# SNOW TEAM TIPS

Vol. 10, No. 8

August, 2002

## **Polaris Model Year 2002 500/600 VES Snowmobiles Overheating**

### **HOW TO PRESSURE TEST COOLANT BOTTLES (12 psi)**

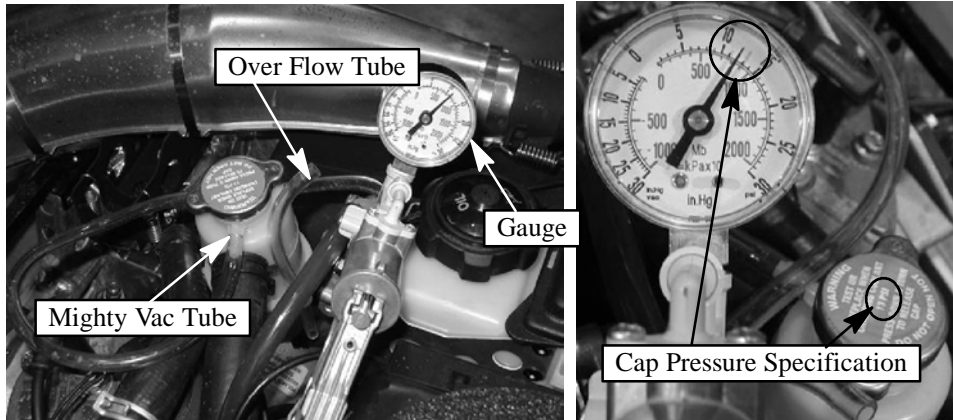
**Step #2. Verify that the coolant system will hold at least 12 psi of pressure.** If the coolant surge bottle is not distorted, and the sealing surface looks fine, pressure test the coolant system. If the cap cannot hold at least 12 psi of pressure, the system will overheat very quickly. The coolant may boil in an otherwise normal operating temperature range disrupting thermistor readings to the CDI box. Test the cooling system as outlined below.

1. With the pressure cap firmly in place, remove the over flow tube (1/4" O.D.) from the neck of the coolant bottle and insert the Mighty Vac™ hose in its place.
2. Set the Mighty Vac™ to apply pressure with the selector lever, and pump the gauge to the specified lbs. for the pressure cap you are testing. The gauge should indicate full pressure and then slowly release the pressure after specified pressure is reached. If the bottle will not hold 12 psi replace the coolant bottle.

Residual Air After Bleeding System

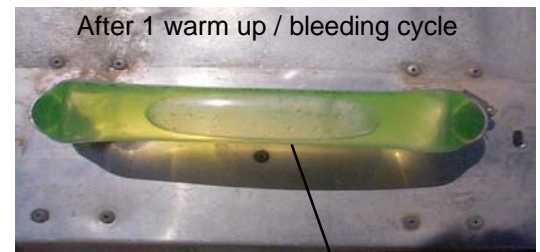
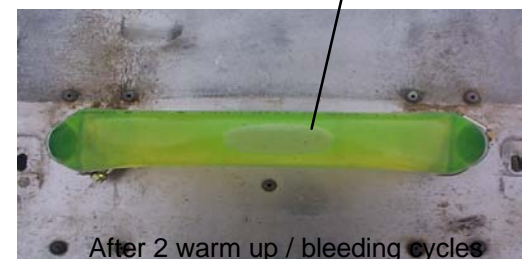
**You may have to perform this operation more than one time!** The photos at right depict air in the rear crossover tube underneath the seat. The top photo shows air remaining after one warm-up cycle. The bottom photo shows almost no air remaining after the second warm-up cycle. (Note: The clear tube shown in the photos has been installed for photography purposes only.)

Place the snowmobile in its normal position and loosen the bleed screw at the top of the water outlet manifold until trapped air has been purged. Tighten the bleed screw. Turn off the machine and release parking brake. Allow the system to cool completely. Re-check the coolant level after the cap has been removed and add coolant to fill line if necessary. Our testing has shown that after the machine has cooled down, 3 ounces or more of coolant may have to be added. This procedure should take approximately 15 minutes.

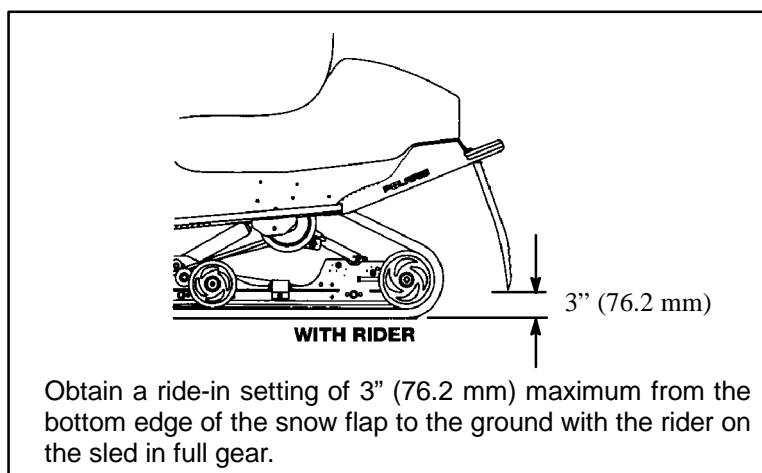
**Step #7. After the new snow flap has been installed, adjust the suspension ride-in for the customer.** This procedure is outlined on the decal located on the underside of the hood, any 2002 Snowmobile Owners Manual or Performance Service Manual PN 9917367. Our testing has shown that the clearance between the ground and the bottom edge of the snow flap should be maximum of 3 inches (76.2 mm) with the rider on the sled and in full gear. Have the customer sit on the sled and adjust the suspension until there are 3 inches (76.2 mm) or less of clearance between the ground and the bottom of the snow flap. If you are unable to reach a maximum of 3 inches (76.2 mm) of clearance, install lighter weight springs. **NOTE:** If the rider is a light person and the suspension is set too stiff there could be an overheat issue because the suspension will not collapse enough for snow to reach the rear strip coolers. If this occurs, replace the original rear suspension torsion springs (coil over spring for M-10 models) with optional lighter springs.

Obtain a ride-in setting of 3" (76.2 mm) maximum from the bottom edge of the snow flap to the ground with the rider on the sled in full gear.

**Step #11. For 500 / 600 VES models with M-10 suspensions only.**

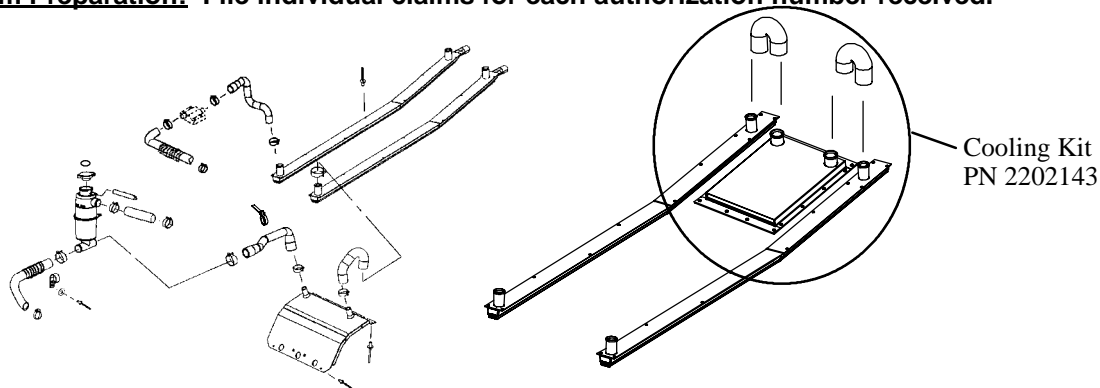
The possibility exists that after performing the steps listed previously, some units with M-10 suspensions may still exhibit overheating issues in certain riding conditions. If you find that the overheating issue still persists, install kit PN 2202143 per SAF-02-04. You may only install this kit after SAF-02-03 has been performed and a warranty claim has been submitted. You will need authorization from Polaris to install this kit to verify that SAF-02-03 has been performed on the unit. Please perform all items thoroughly and completely. Read and understand the kit instructions completely before attempting the procedure.

<u>Qty.</u>	<u>Part Description</u>	<u>Part No.</u>
1	Cooler Kit, EDGE	2202143
